2.15 Structures and Servicing Systems

The information in this section of the reference ABWR DCD, including all subsections, tables, and figures, as modified by the STP Nuclear Operating Company Application to Amend the Design Certification rule for the U.S. Advanced Boiling Water Reactor (ABWR), "ABWR STP Aircraft Impact Assessment (AIA) Amendment Revision 3," dated September 23, 2010 is incorporated by reference with the following departures.

Table 2.15.5c Reactor Building Safety-Related Equipment HVAC System

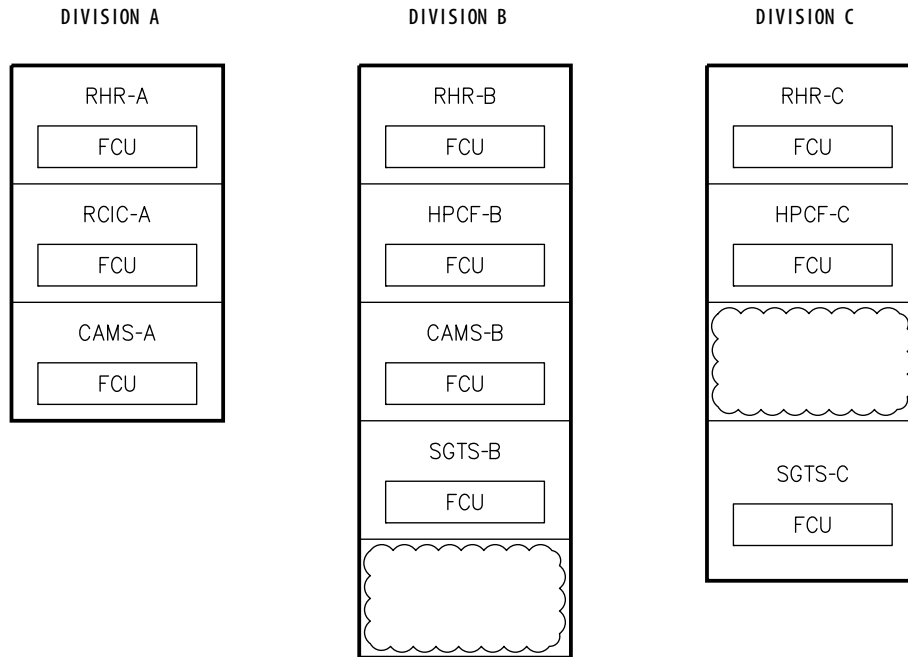
Inspections, Tests, Analyses and Acceptance Criteria		
Design Commitment	Inspections, Tests, Analyses	Acceptance Criteria
4. The FCS room FCUs are initiated upon a manual FCS start signal. <u>Not used.</u>	4. Tests will be conducted on each as built FCS room FCU using a simulated initiation signal. <u>Not used.</u>	4. The FCS room FCU starts upon receipt of a signal indicating FCS start. <u>Not used.</u>

Figure 2.15.5e Reactor Building Safety-Related Equipment HVAC System

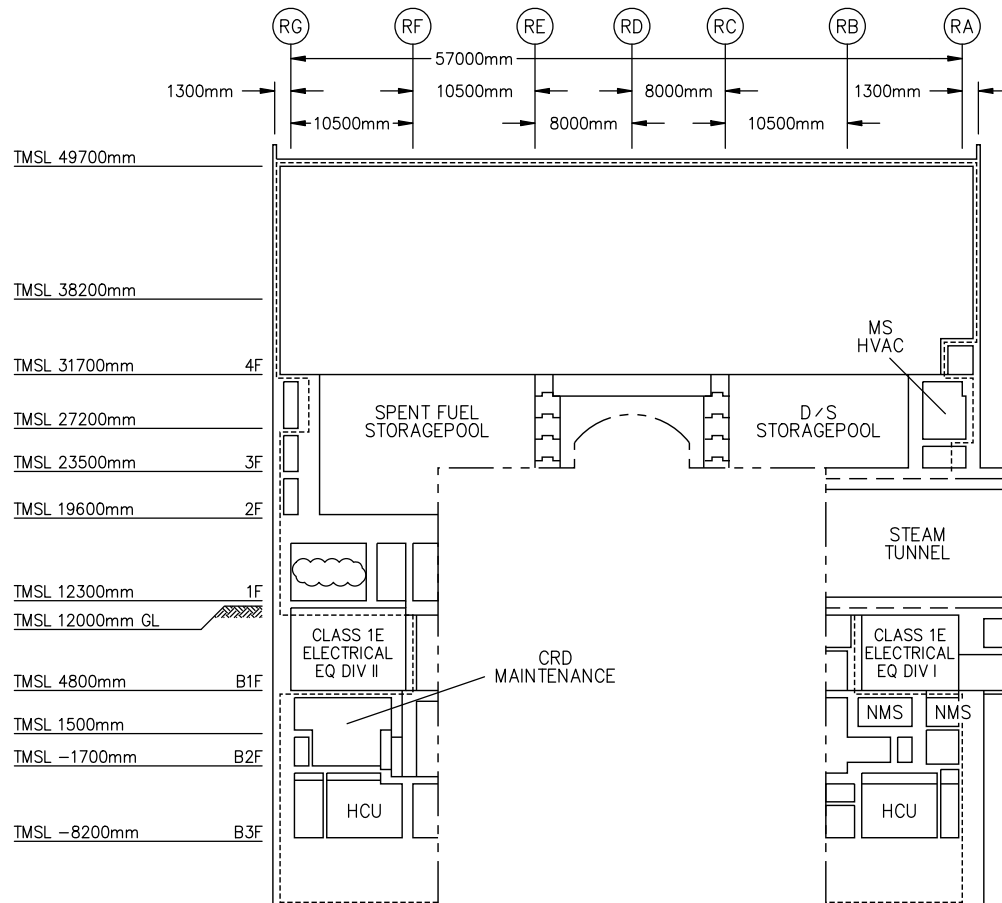
STD DEP T1 2.14-1 (Figure 2.15.10a, Figure 2.15.10j, Figure 2.15.5e, Table 2.15.5c)

The R/B Safety-Related Equipment HVAC System provides cooling of safety-related equipment areas, and consists of independent fan coil units. Figure 2.15.5e shows the basic system configuration and scope.

The Residual Heat Removal (RHR) System, High Pressure Core Flooder (HPCF) System and Reactor Core Isolation Cooling (RCIC) System pump room FCUs are automatically initiated upon startup of their respective room process pump. The Containment Atmospheric Monitoring System (CAMS) and Standby Gas Treatment System (SGTS) room FCUs are automatically initiated upon isolation of the Reactor Building Secondary Containment HVAC System. ~~The Flammability Control System (FCS) room FCUs are also initiated upon a manual FCS start signal.~~

Figure 2.15.12a Control Building Arrangement, Section A-A

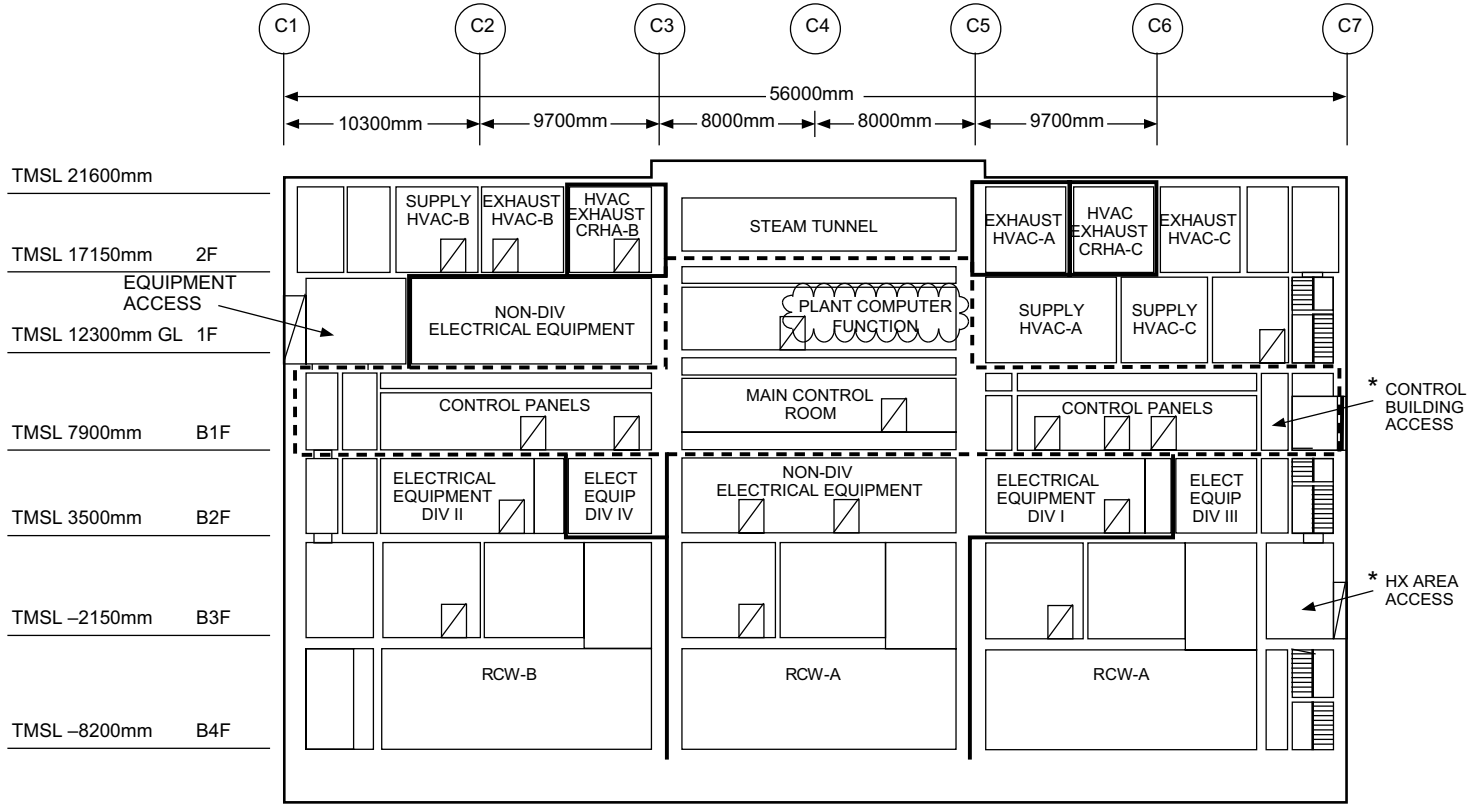
STD DEP T1 3.4-1 (Figure 2.15.12a, Figure 2.15.12b, Figure 2.15.12g)
